S/D No. 83-8 Name Lakeview Mobile Home Park 3rd Addition
Date Application Rec'd. 2-6-83 Preliminary Approval 3-3-83
Scheduled S/D Meeting 3-31-83

Preliminary plat
SUBDIVISION REPORT

SUBDIVISION COMMITTEE
METROPOLITAN AREA
PLANNING COMMISSION

Re: S/D 83-8 - Preliminary plat of Lakeview Mobile Home
Park 3rd Addition

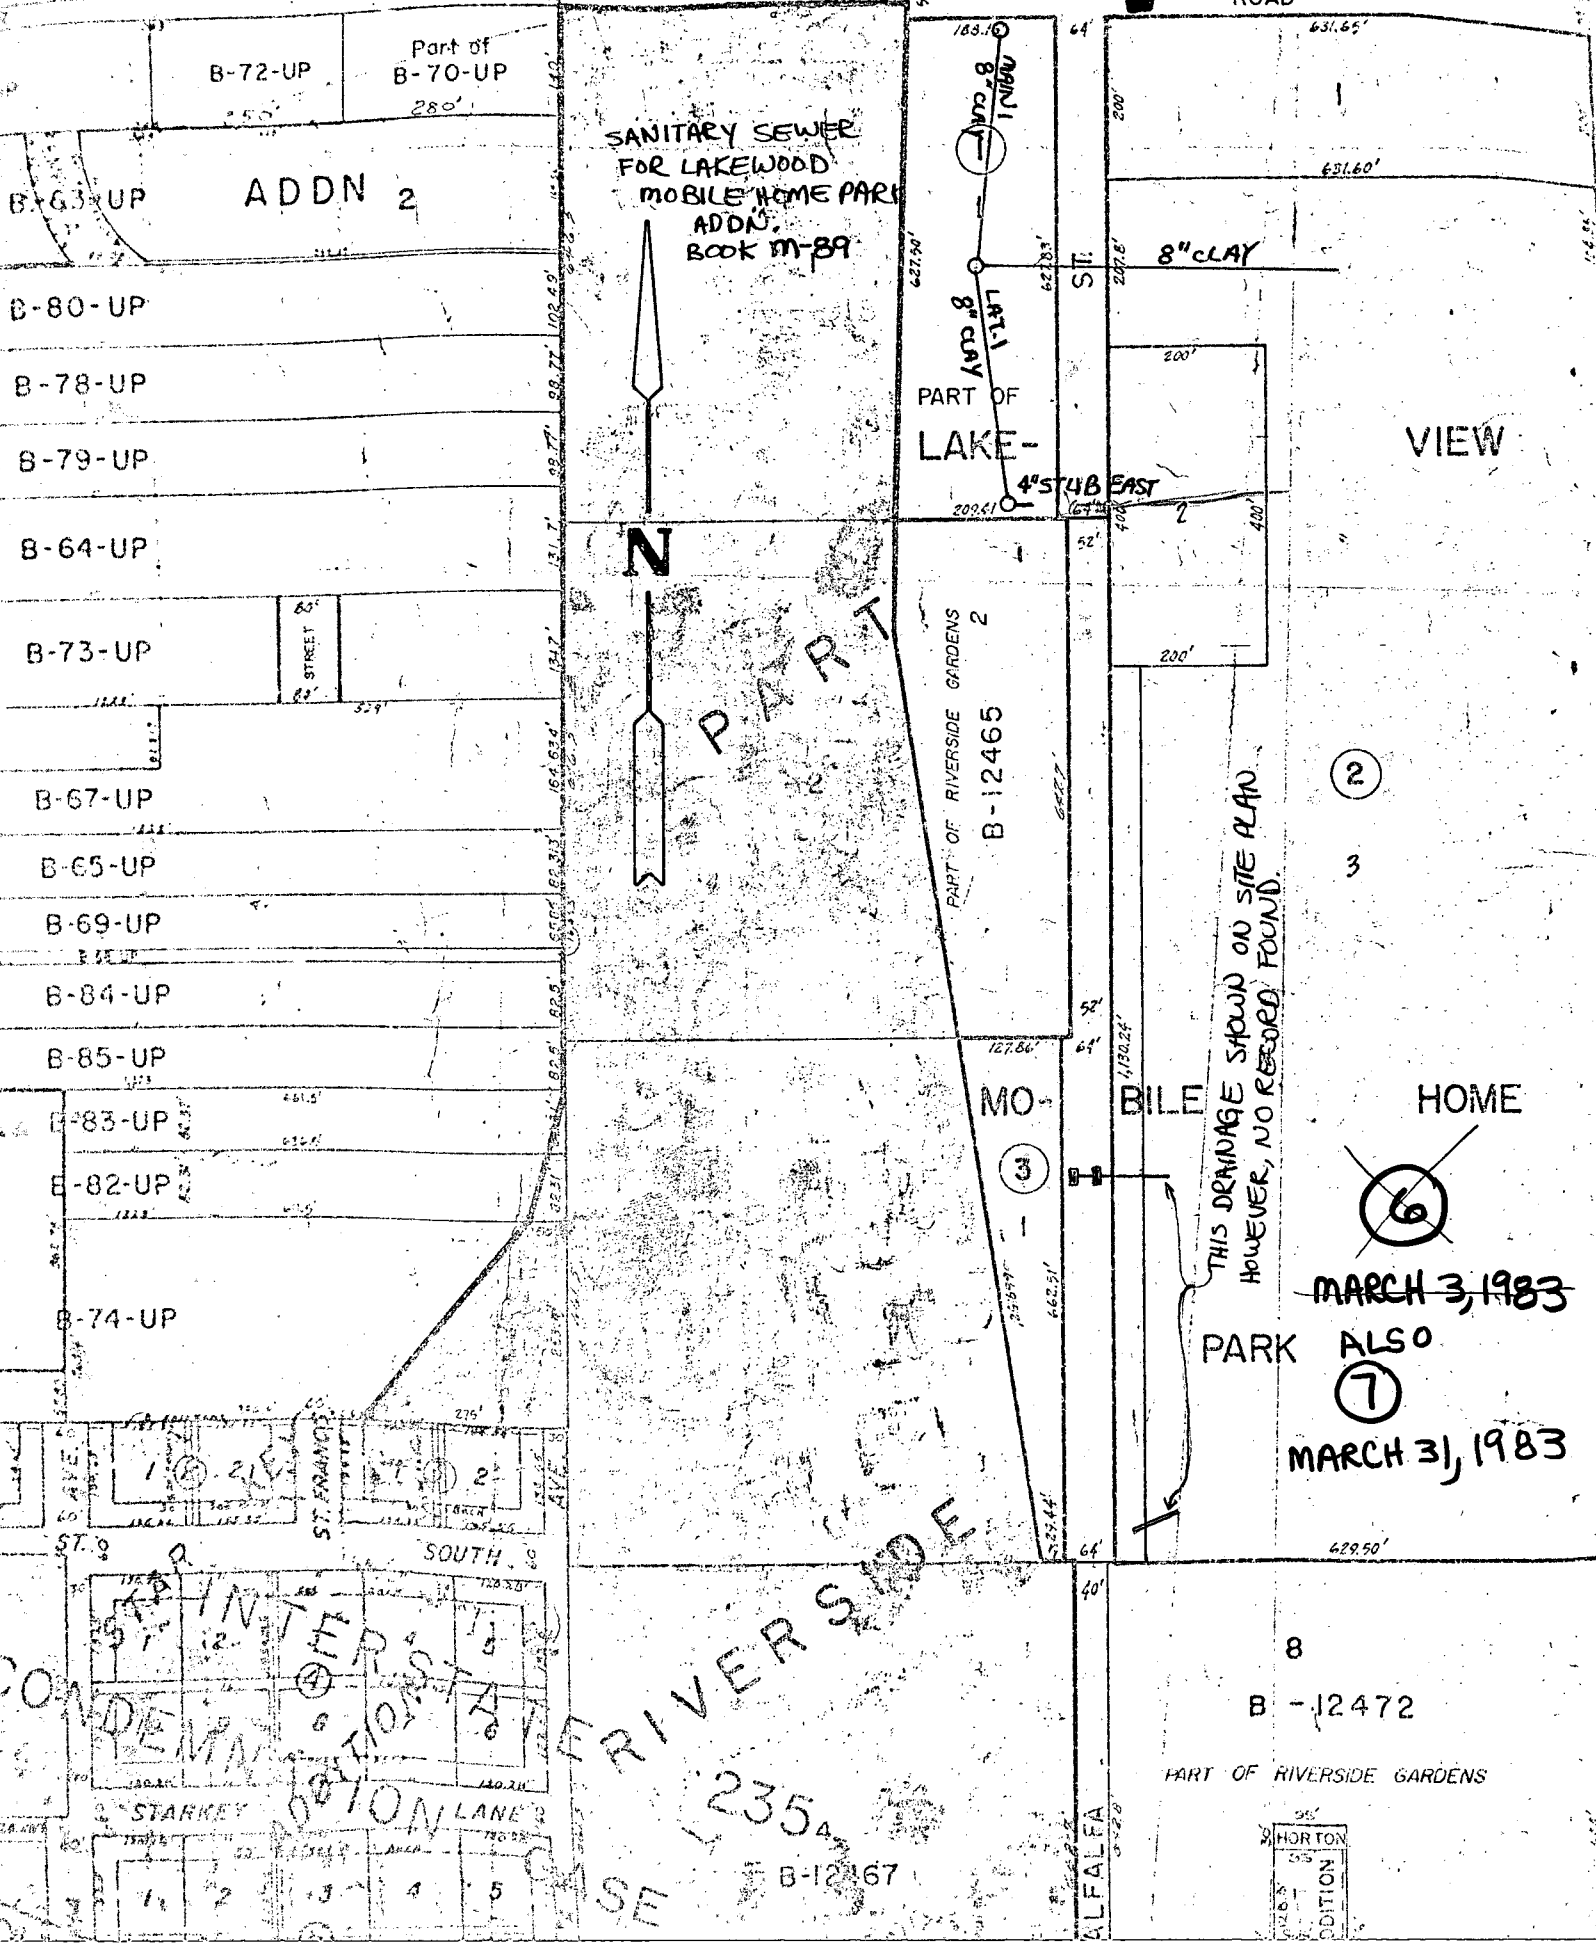
THIS DRAINAGE SHOWN ON SITE PLAN
HOWEVER, NO RECORD FOUND

MARCH 3, 1983
PARK ALSO
MARCH 31, 1983
